FAA Implementation of ACR Recommendation 3

Return CAATT Waypoint to Pre-Metroplex location

July 2024

FILPZ FOUR ARRIVAL (RNAV)

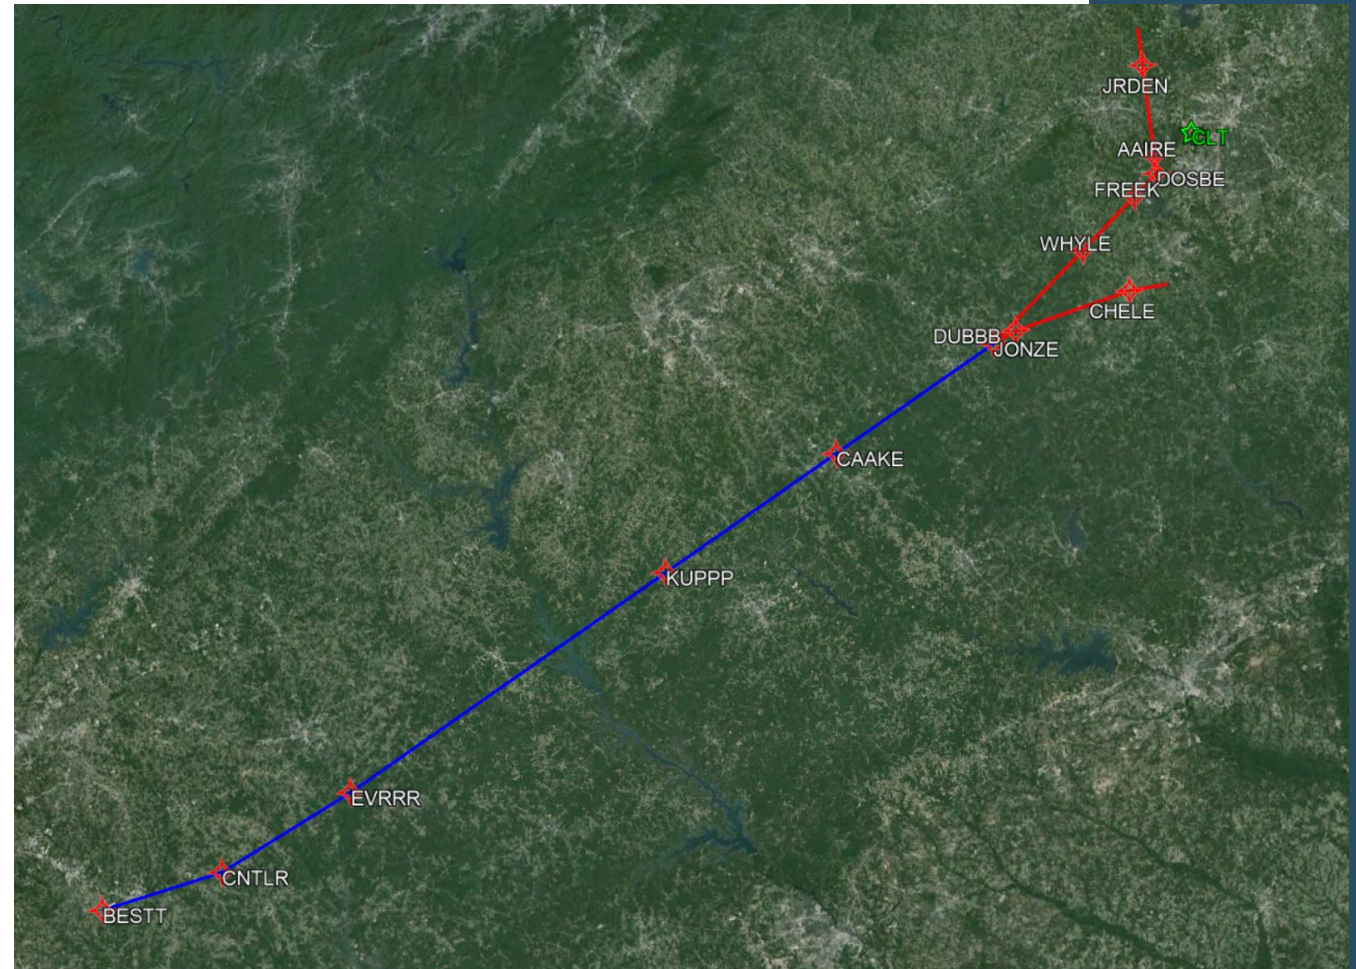
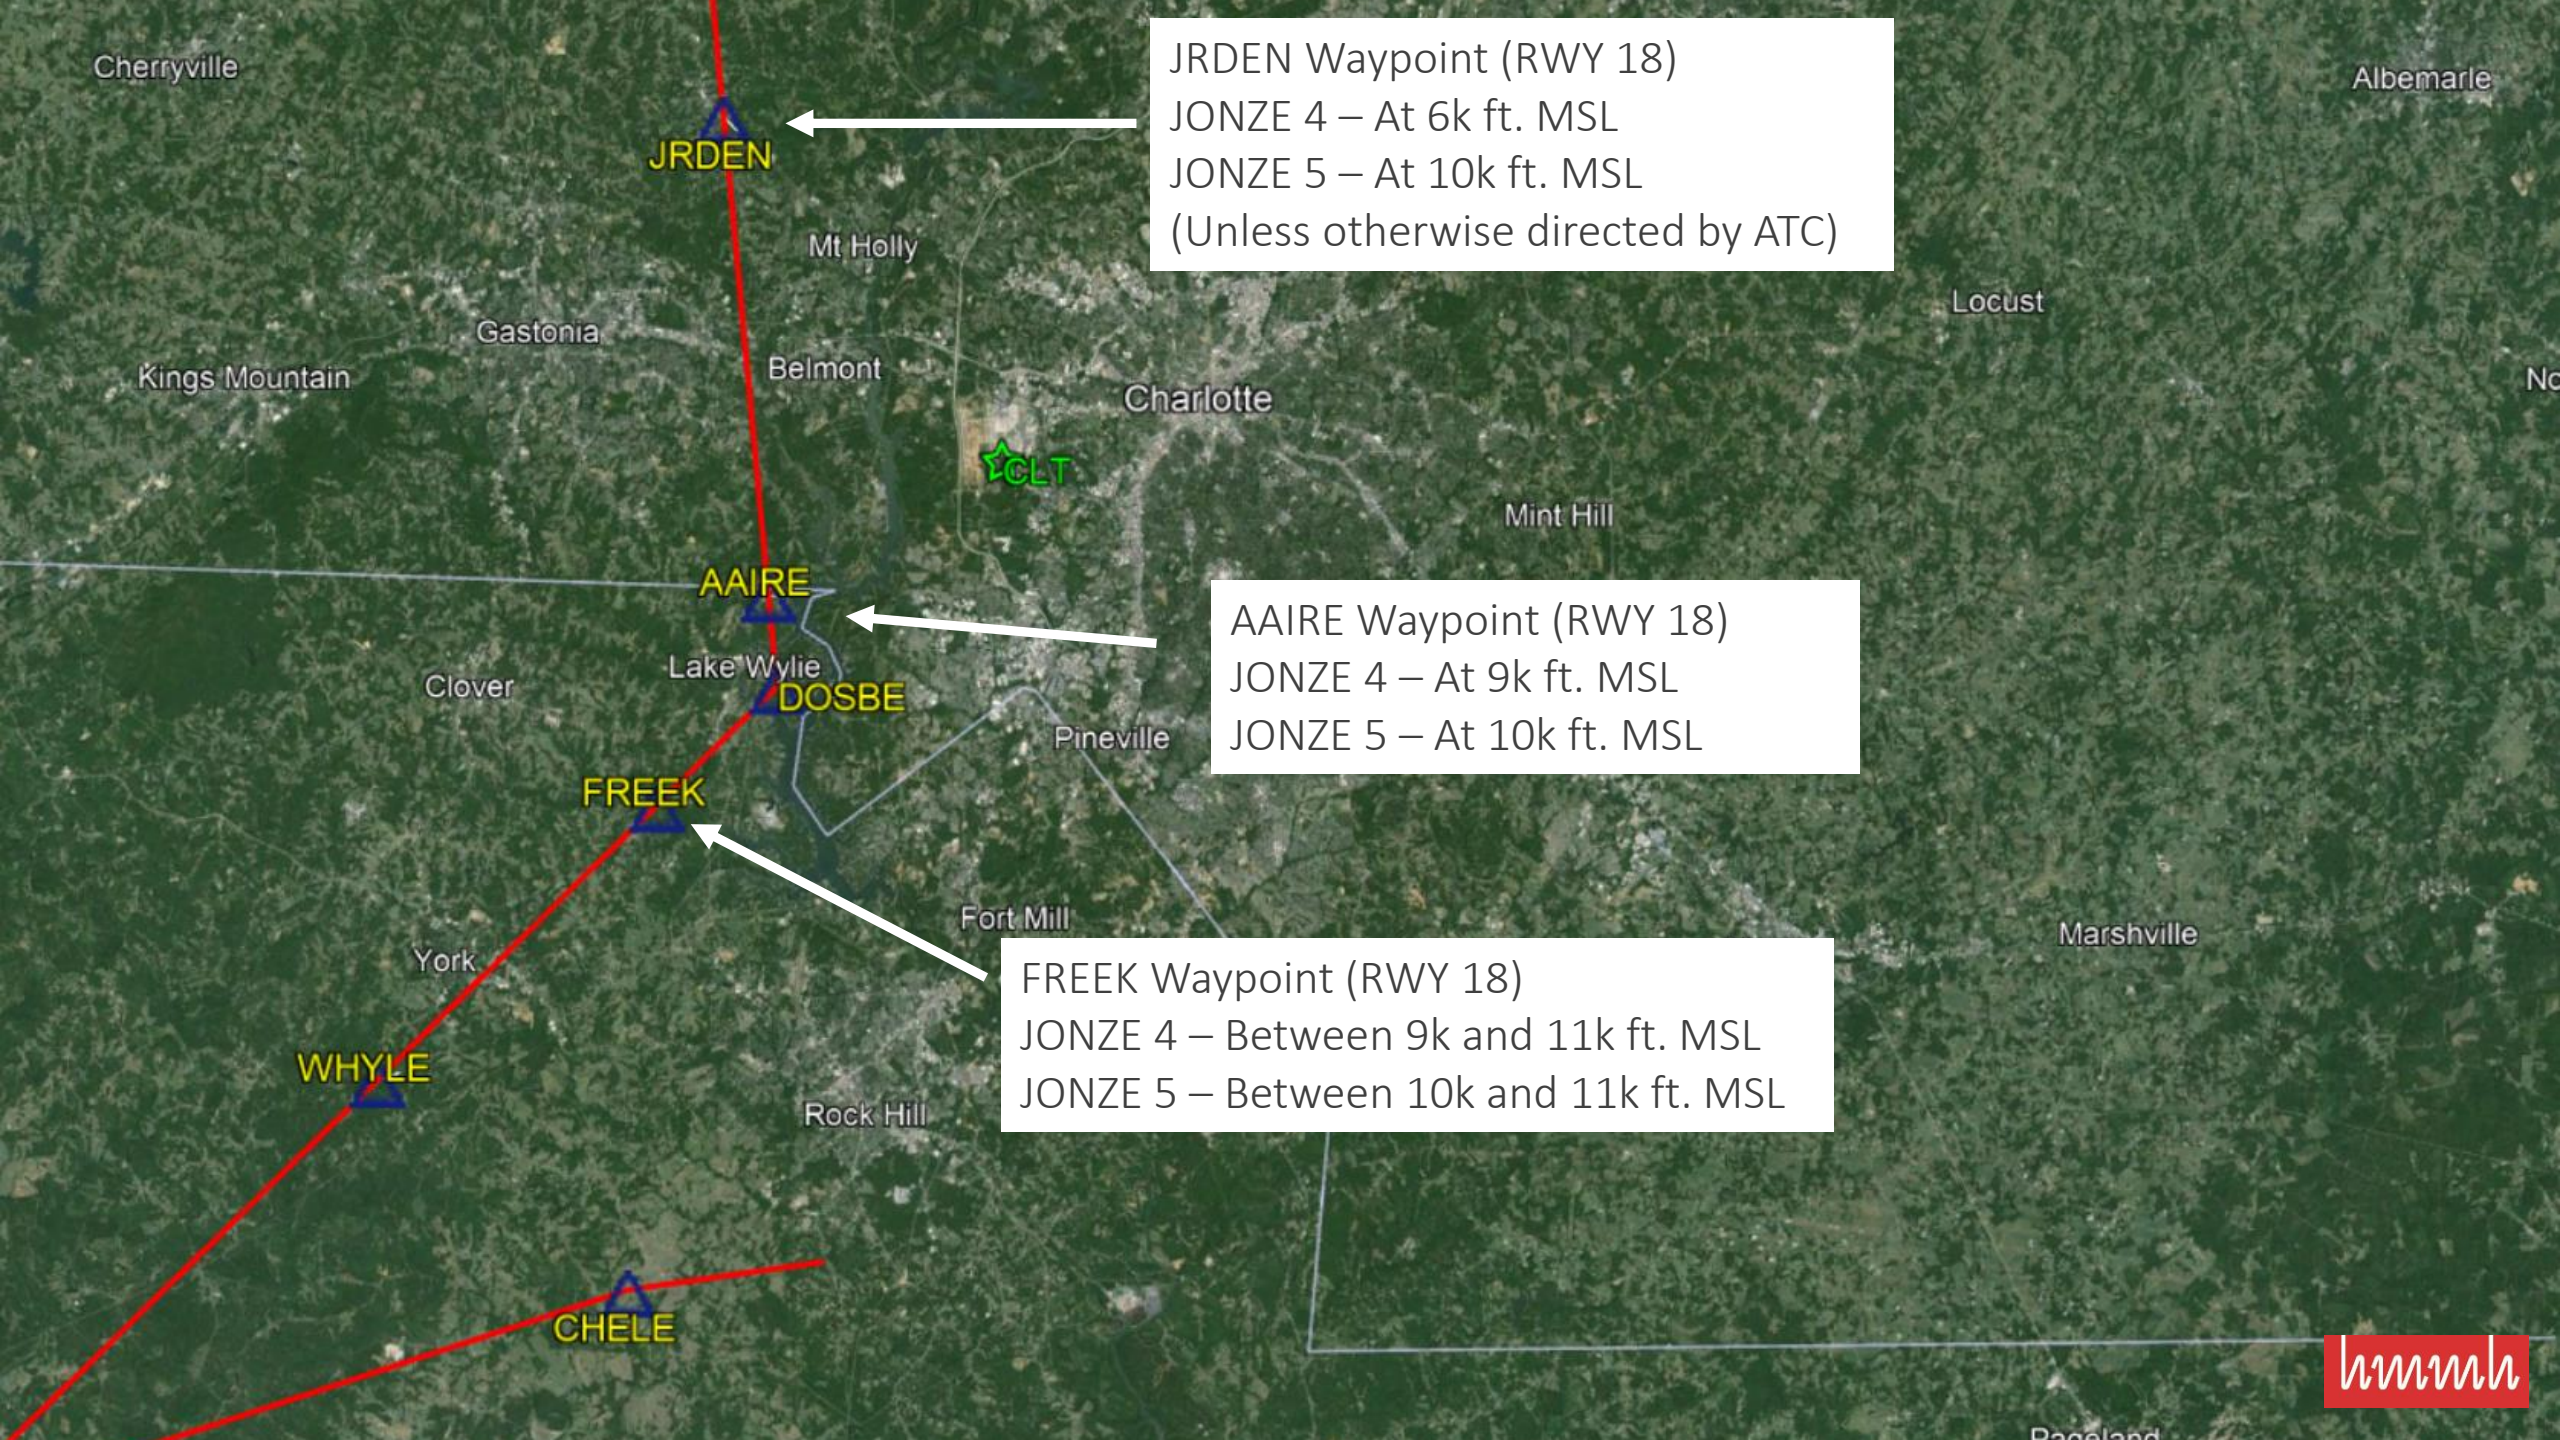
- Altitude changes:
 - VALLL – removed 6k ft. MSL altitude restriction
 - CEDOX – raised altitude restriction from 9k to 10k ft. MSL
 - GLAXI – changed altitude restriction from at or above 12k to between 12k and 14k ft. MSL
 - JOBOT – changed altitude restriction from between 11k and 12k ft. MSL to at 11k ft. MSL

JABOT Waypoint (RWY 18)
FILPZ 3 – Between 11k and 12k ft. MSL
FILPZ 4 – At 11k ft. MSL

GLAXI Waypoint (RWY 18)
FILPZ 3 – At or above 12k ft. MSL
FILPZ 4 – Between 12k and 14k ft. MSL

CEDOX Waypoint (RWY 36)
FILPZ 3 – At 9k ft. MSL
FILPZ 4 – At 10k ft. MSL

VALLL Waypoint (RWY 36)
FILPZ 3 – At 6k ft. MSL
FILPZ 4 – At 10k ft. MSL
(unless otherwise directed by ATC)

MLLET THREE ARRIVAL (RNAV)

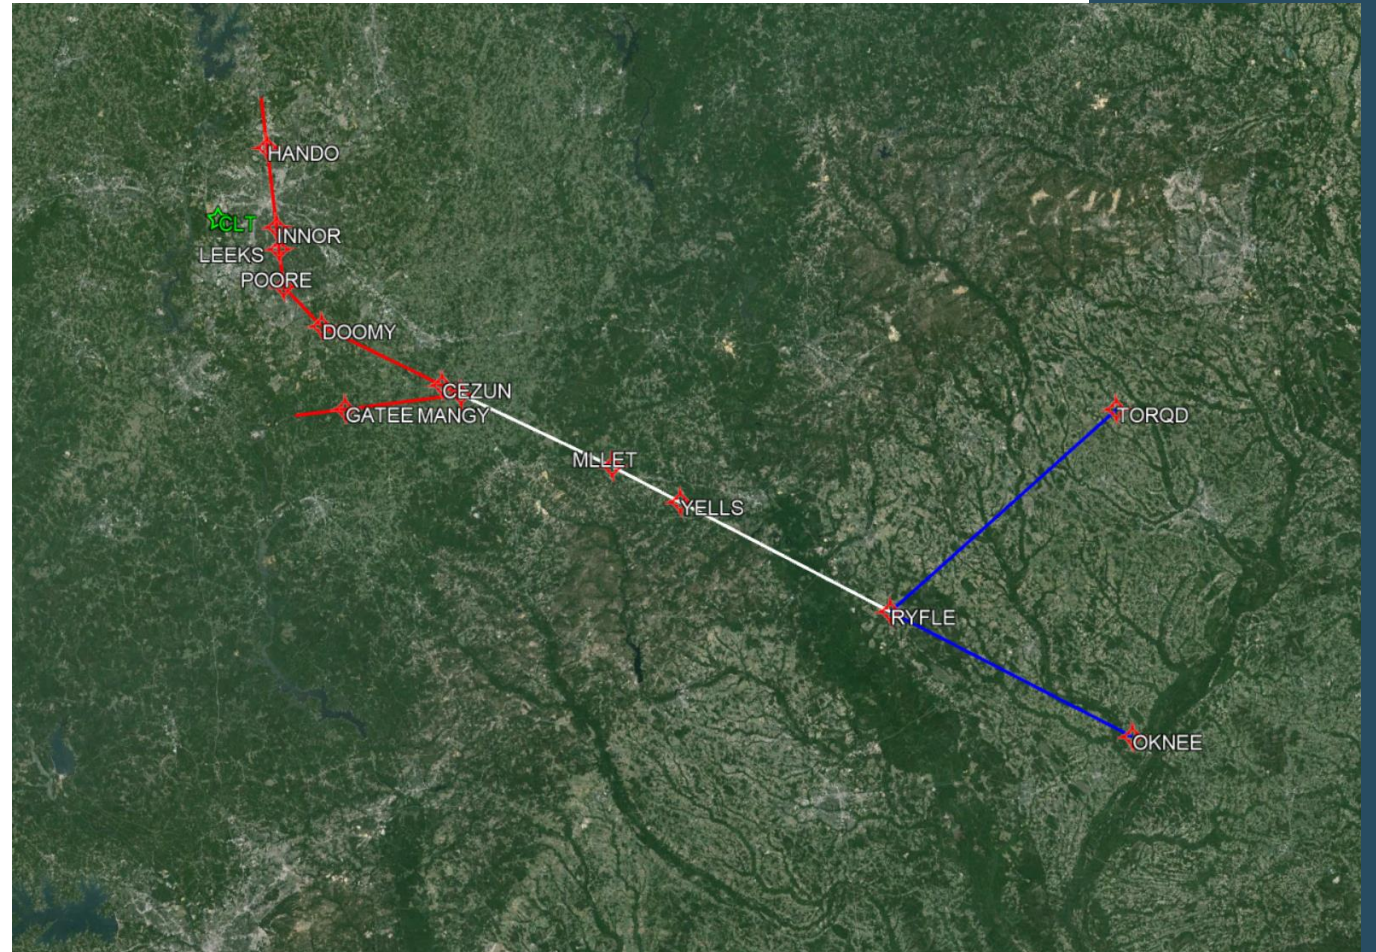
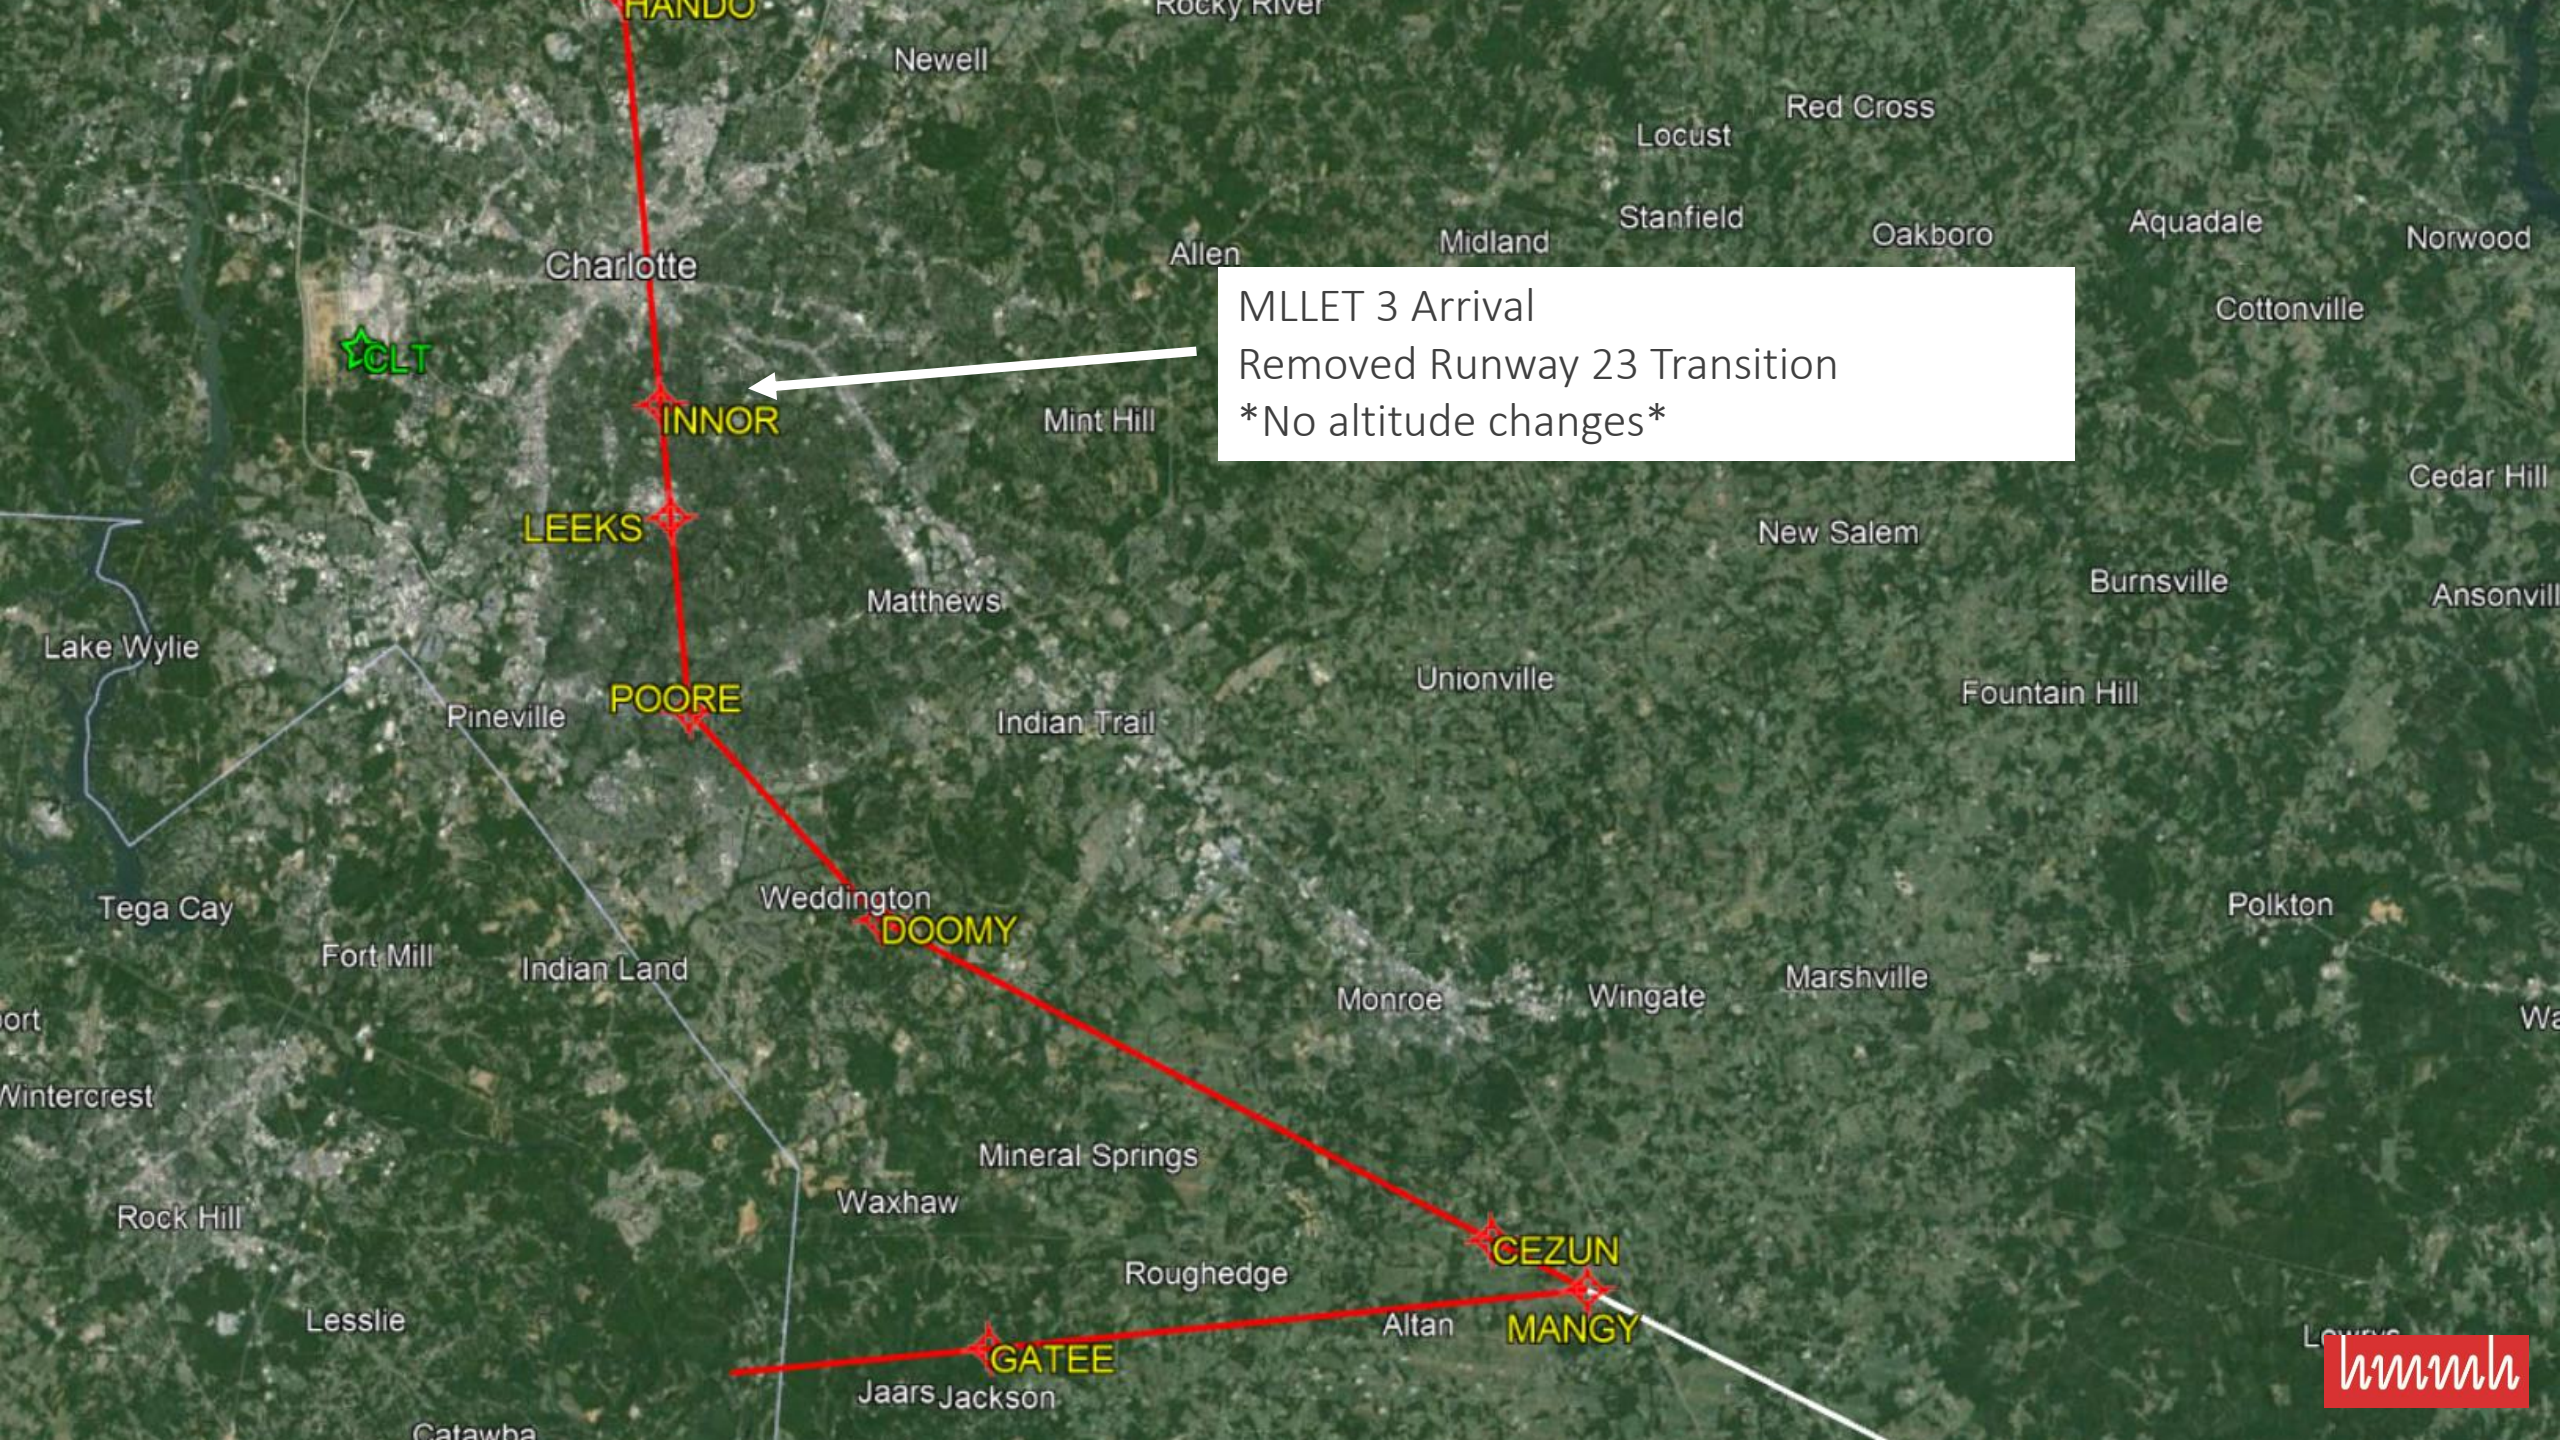
- Altitude changes:
 - None
 - *Removed Rwy 23 Transition

MLLET 3 Arrival
Removed Runway 23 Transition
No altitude changes
